Clause 137 Channel Insertion Loss

Ali Ghiasi
Ghiasi Quantum LLC

IEEE 802.3cd Task Force Meeting

Nov 7th, 2016

Clause 137 Channel Response

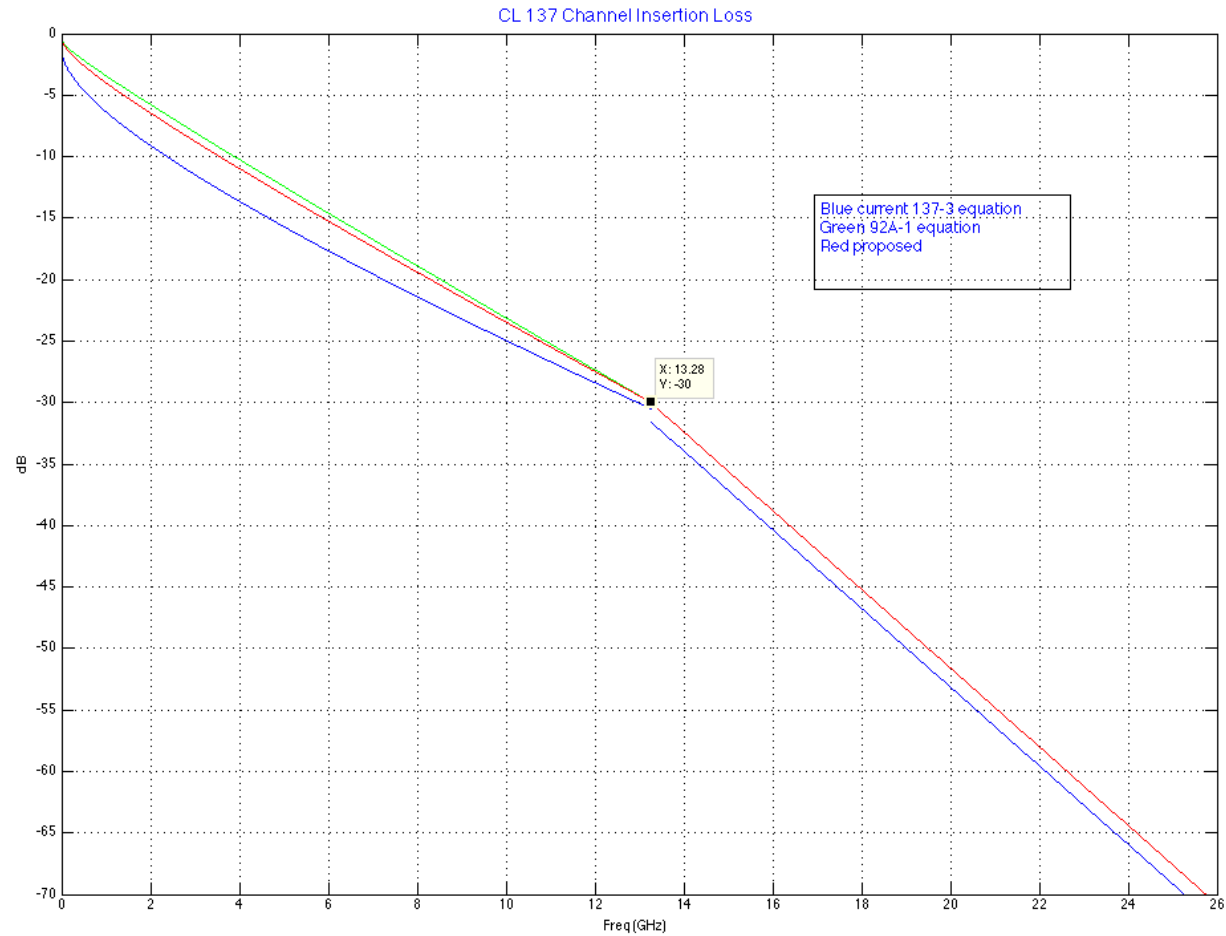
- ❑ **Current clause 137 PMD sublayer for type 50GBASE-KR, 100GBASE-KR2, and 200GBASE-KR4 has very strong \sqrt{f} response**
 - The recommended channel response has 750% stronger \sqrt{f} than clause 92A
- ❑ **To better fit material lower loss than Megtron 6 should increase \sqrt{f} coefficient of clause 92 A but there is no reason to increase the coefficient by 7.5x**
- ❑ **In support of comment 122 which proposes to increase the \sqrt{f} coefficient by ~2.2x compare to CL92A.**

□ In comparisons to clause 92A and proposed response

$$IL_{PCB} \leq \begin{cases} 0.4842 + 1.744\sqrt{f} + 1.744 \times f & \text{for } 0.01 \leq f \leq fb/2 \\ -12.44 + 3.2 \times f & \text{for } fb/2 \leq f \leq fb \end{cases} \text{ (dB)}$$
